Town of Hilton Head Island Regular Design Review Board Meeting

March 22, 2016

DESIGN TEAM/DRB COMMENT SHEET

ELEV 1 EAST #1 - BLDG A - NORTH
1/8" = 1'-0" 3.A

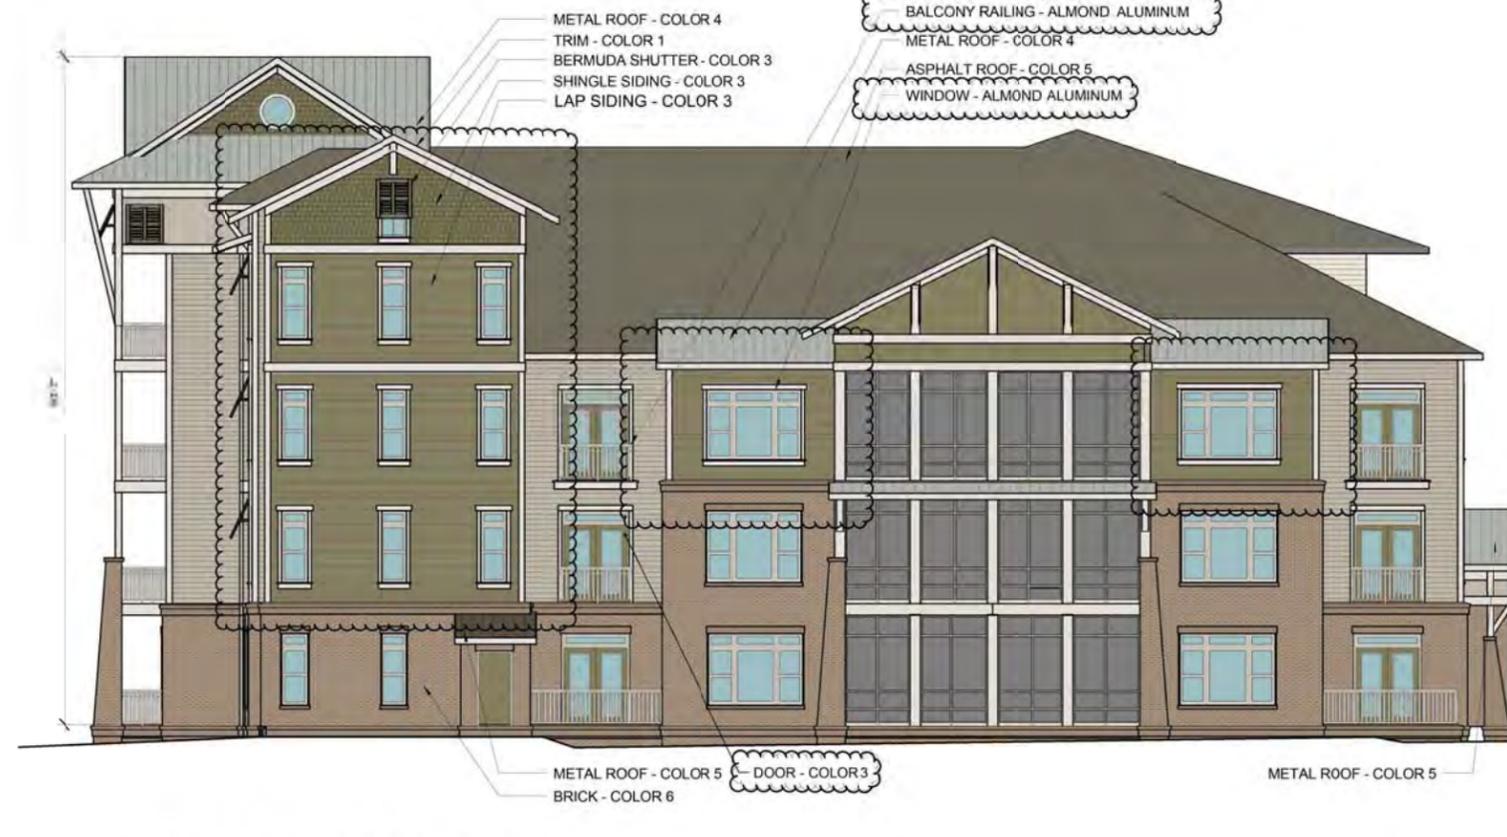
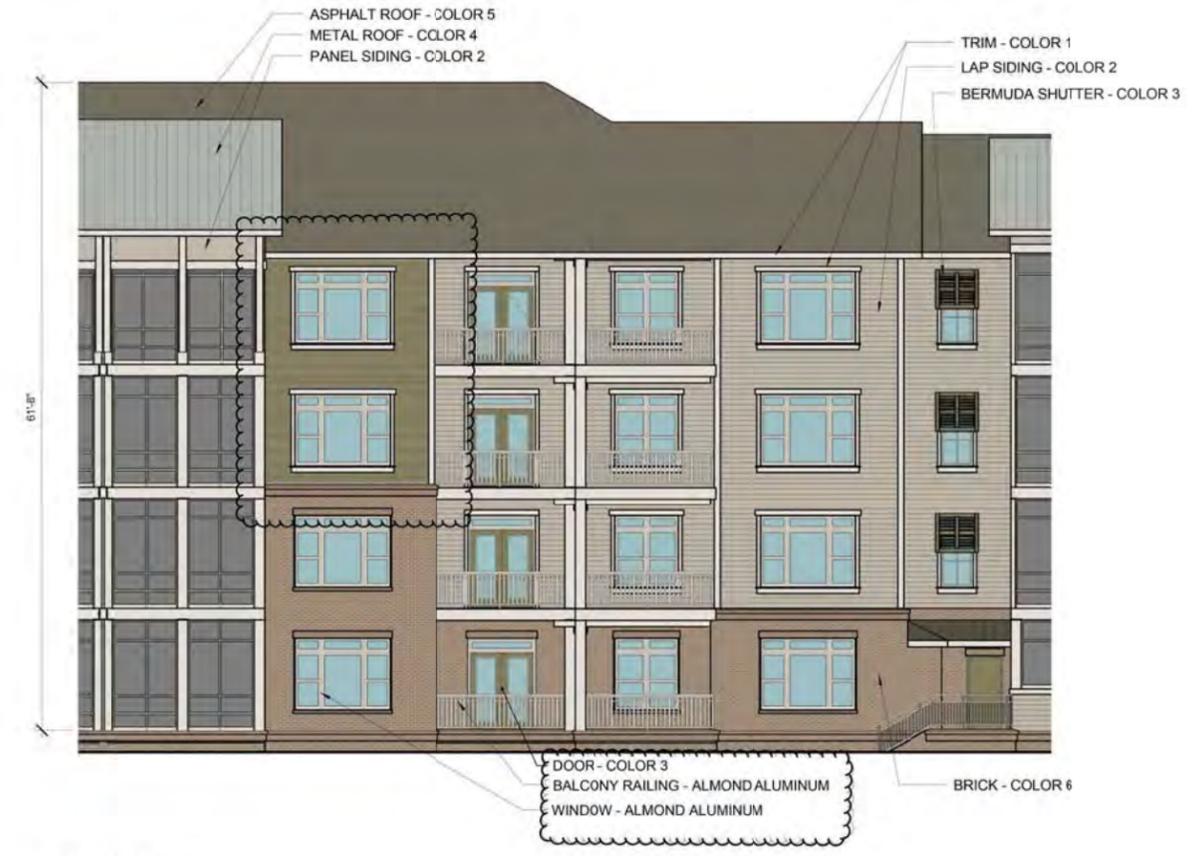
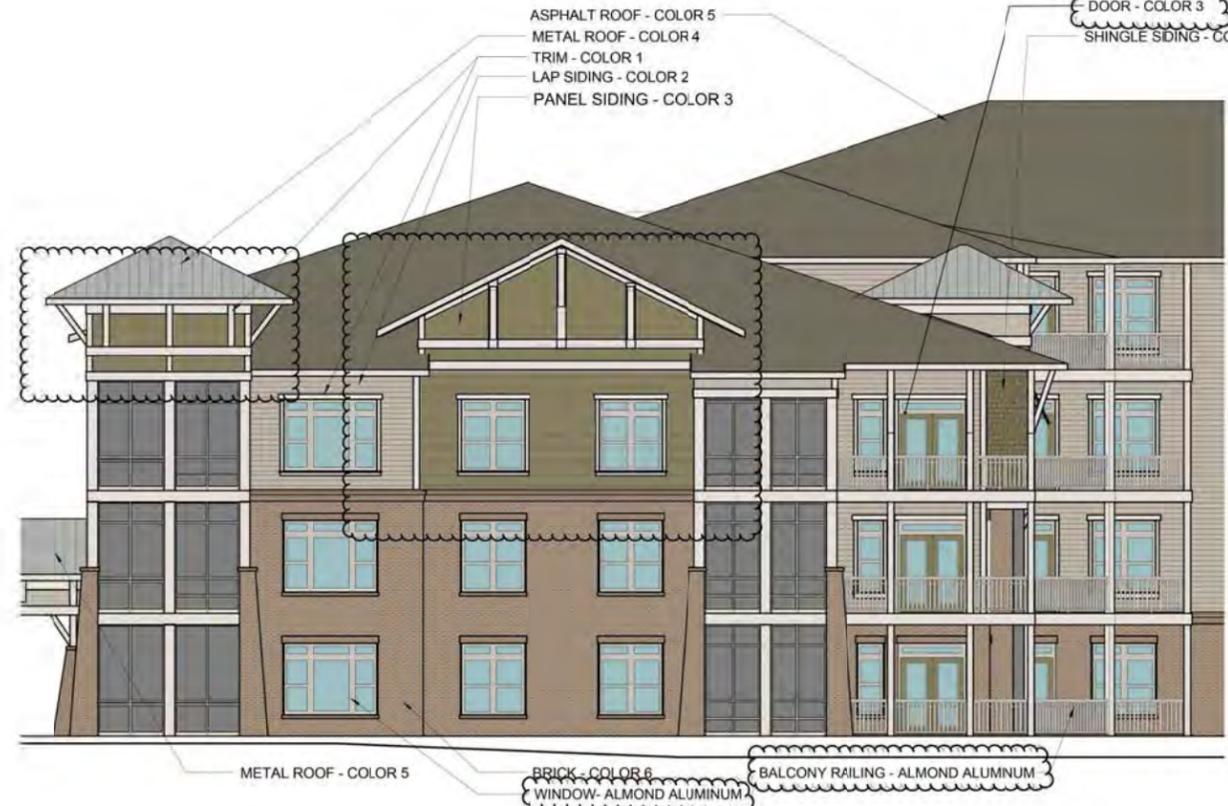
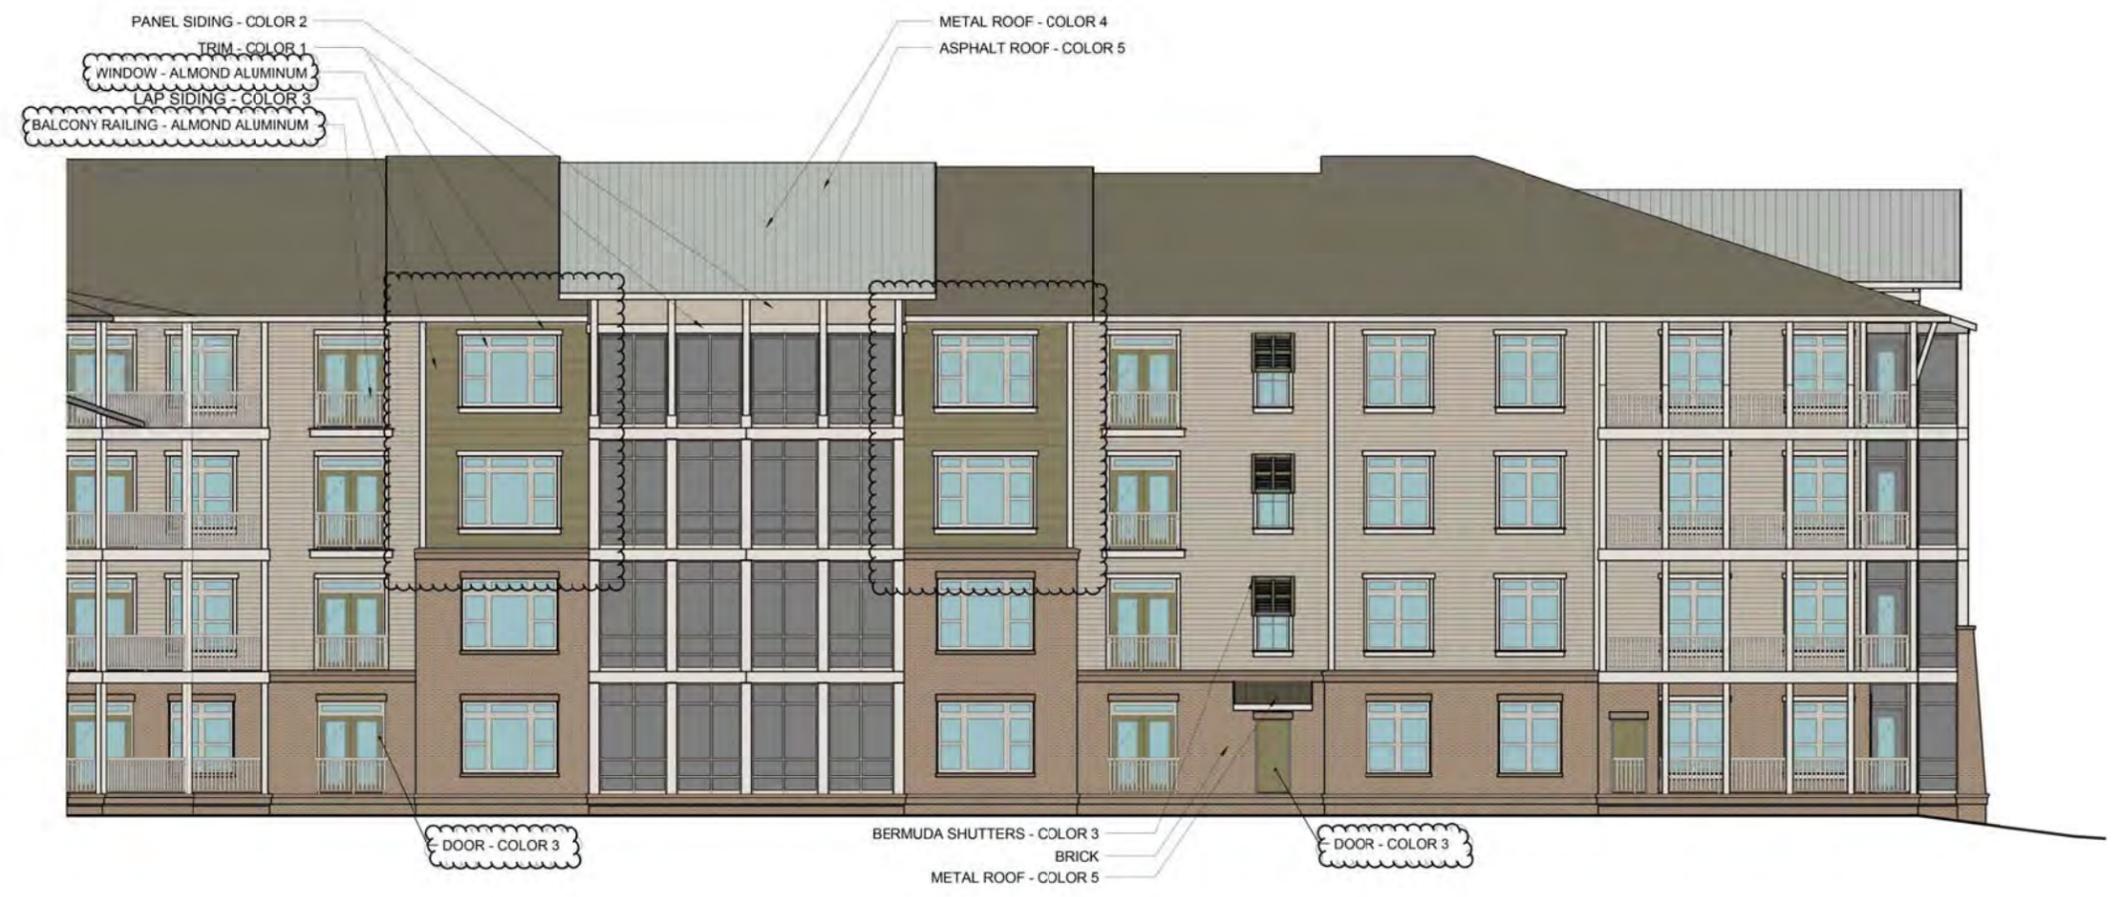
Minor changes are proposed to the approved building elevations due to unit type changes. A fourth tier was added to the parking deck requiring modifications to the Shelter Cove Lane façade. Additionally the base flood elevation had to be increased by 1' requiring steps and ramps at the leasing office entry. Proposed changes are in keeping with previously approved plans and with the Design Guide.

1/8" = 1'-0" 1 EAST #1 - BLDG A - NORTH

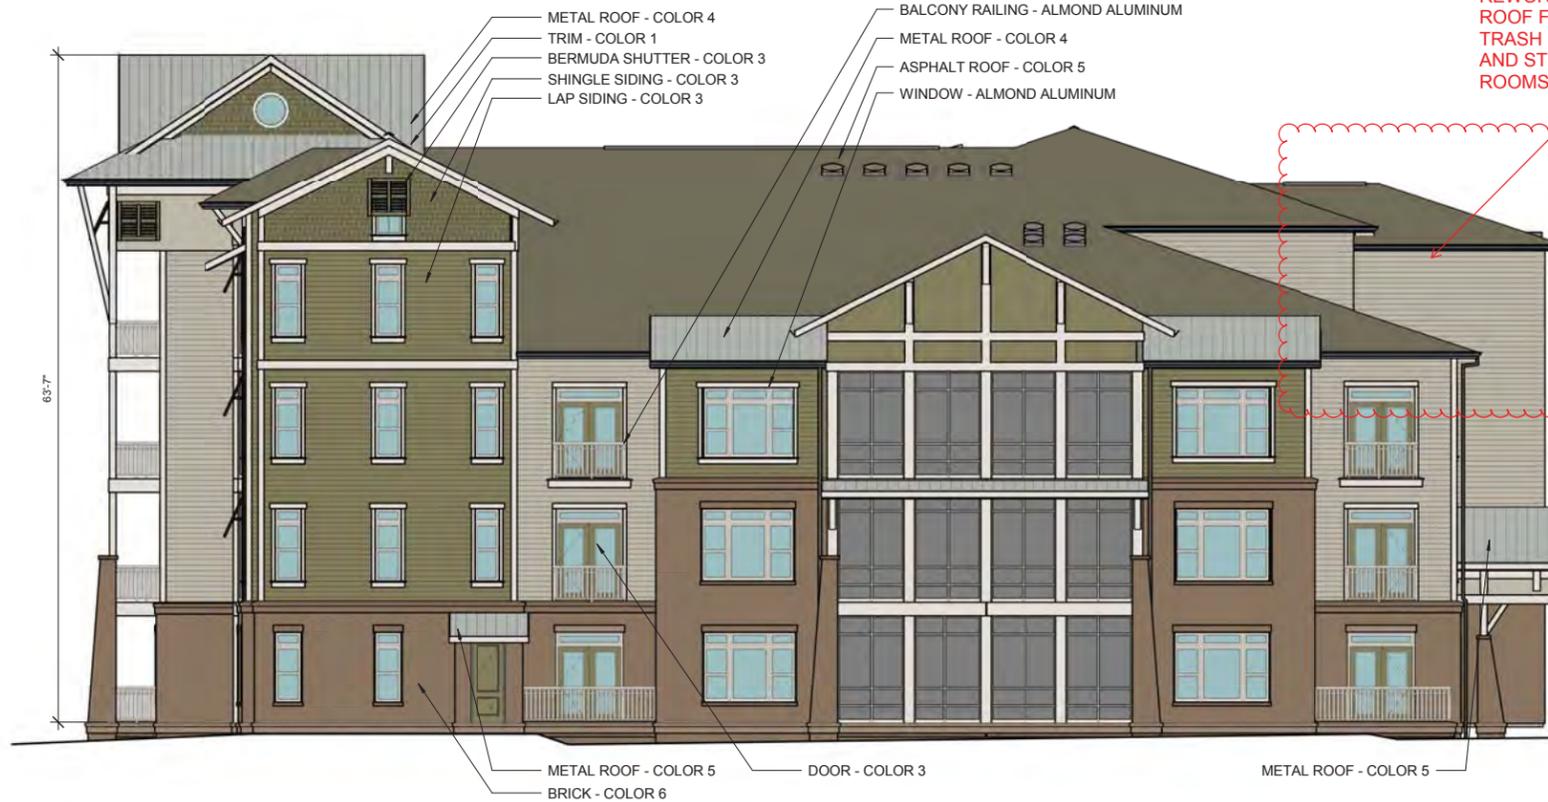
ADDED STAIR TOWER FOR EGRESS

REWORKED ROOF FOR TRASH ROOM AND STORAGE ROOMS

SHELTER COVE HARBOUR: LARGE SIGN (EXISTING)

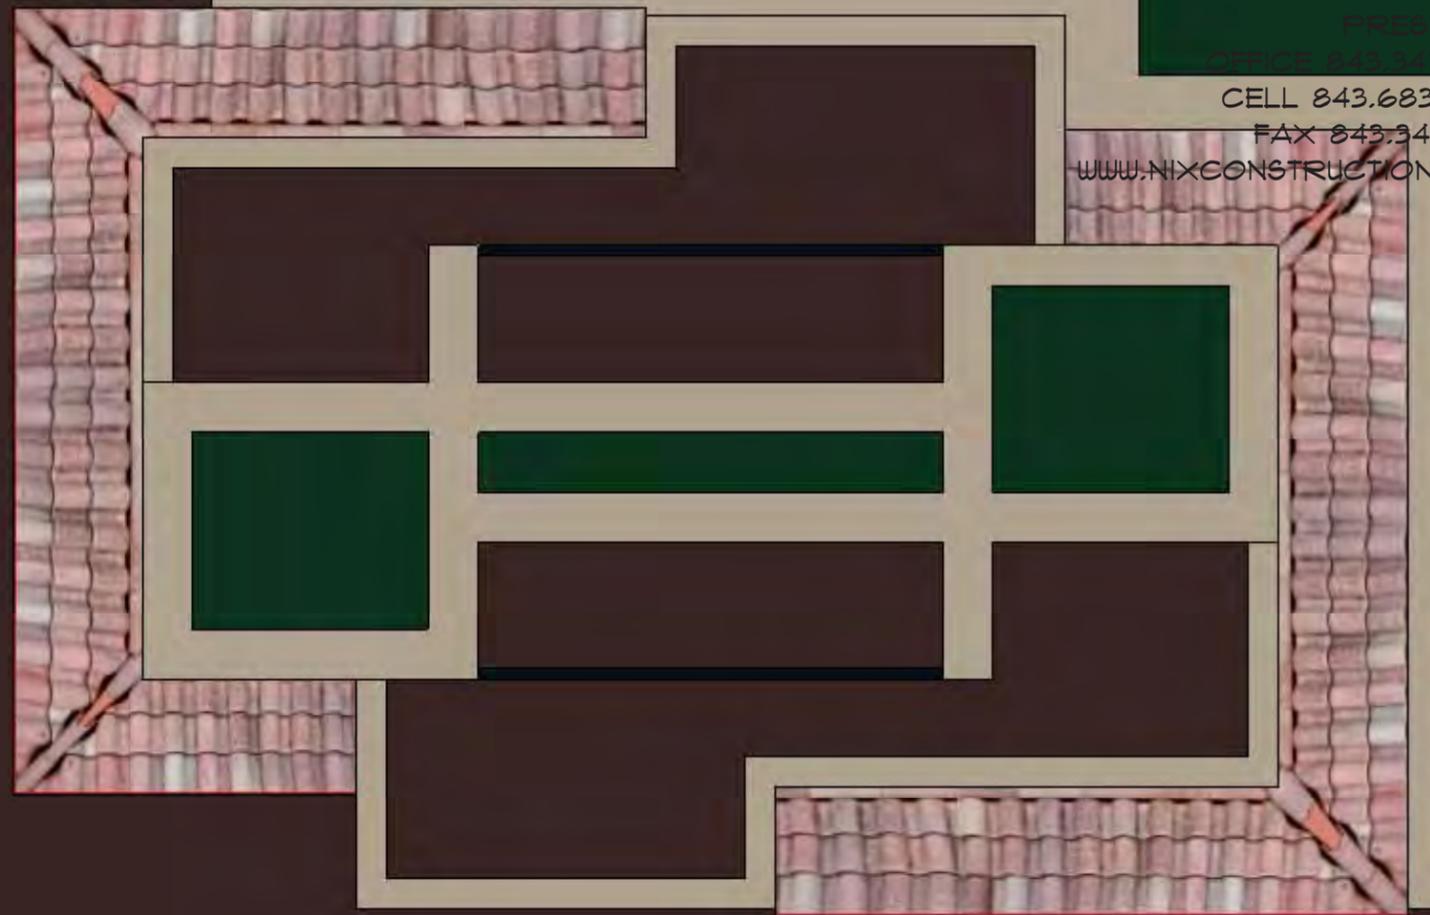
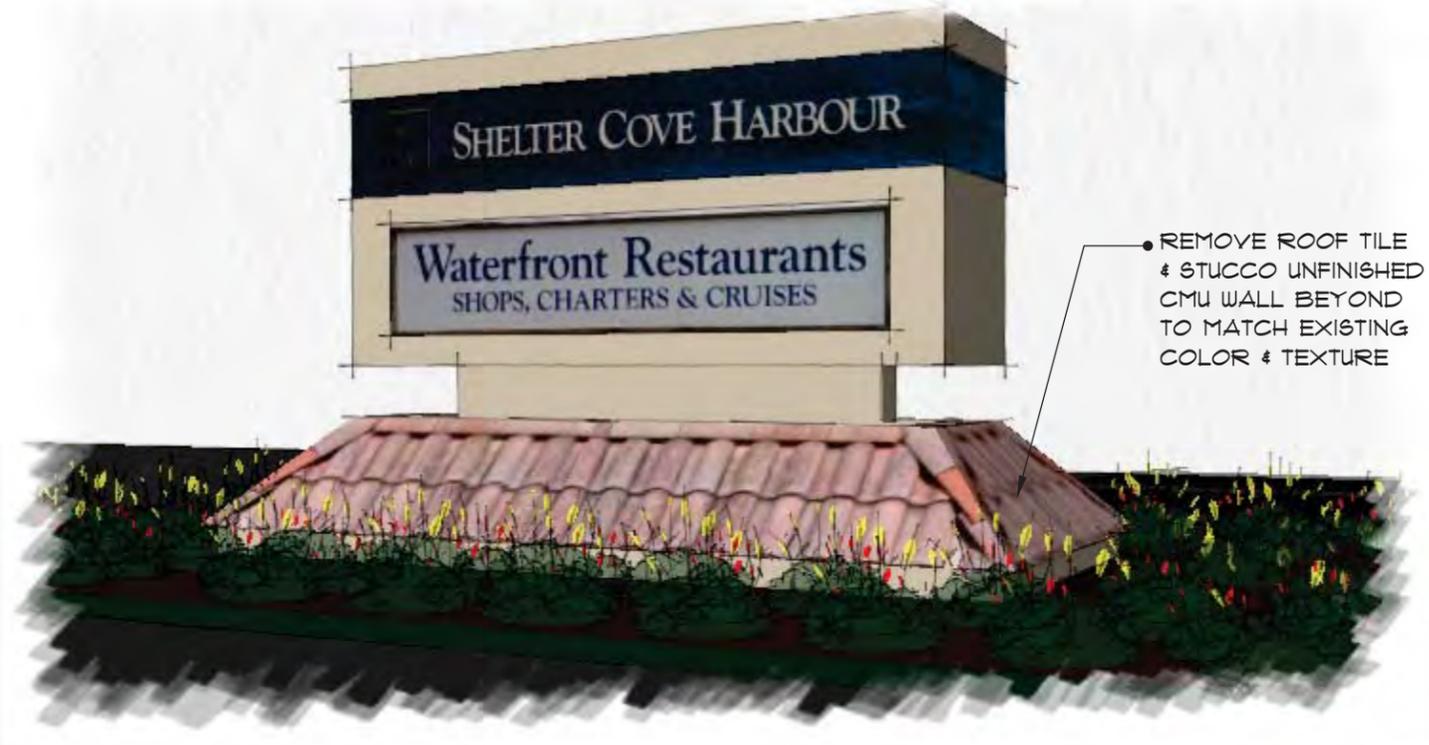
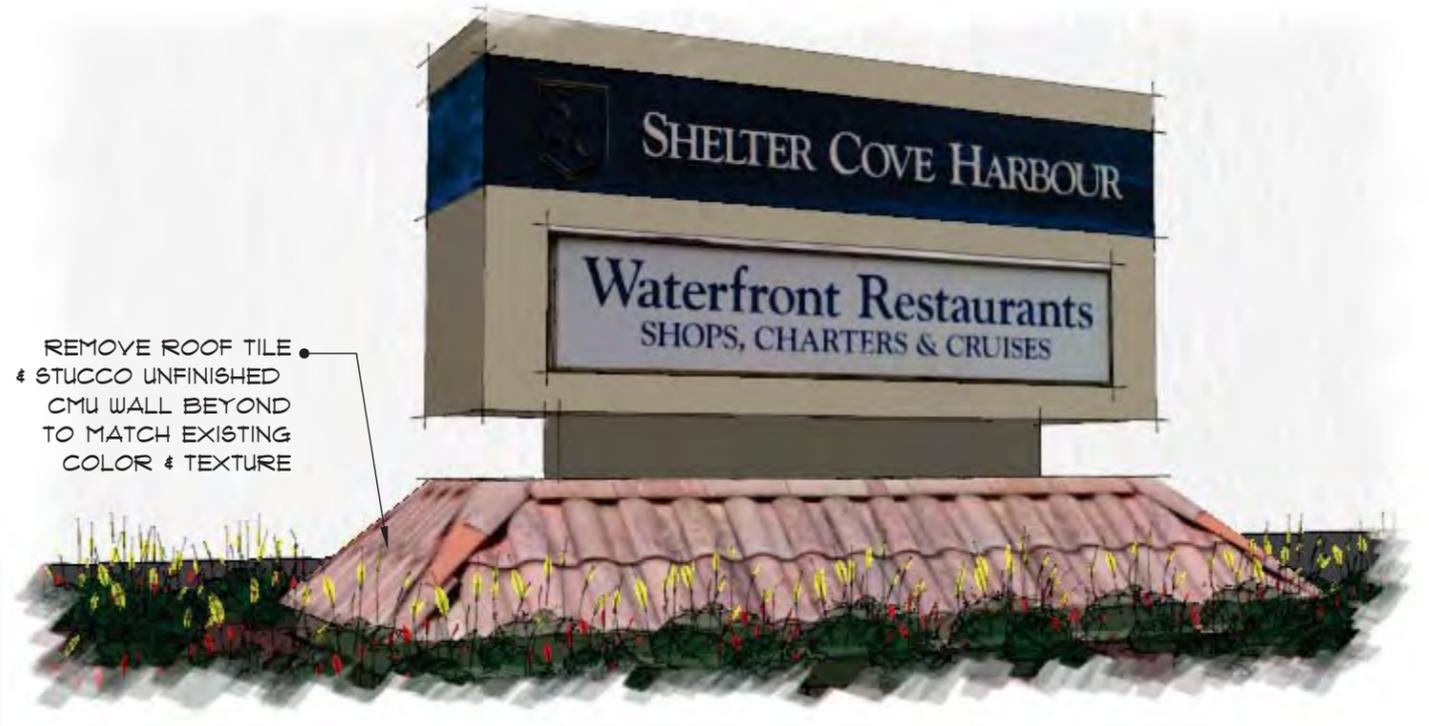
Applicant proposes to remove existing Spanish tiles from two monument signs and expand stucco planters. Stucco will match existing. Planters will include seasonal color.
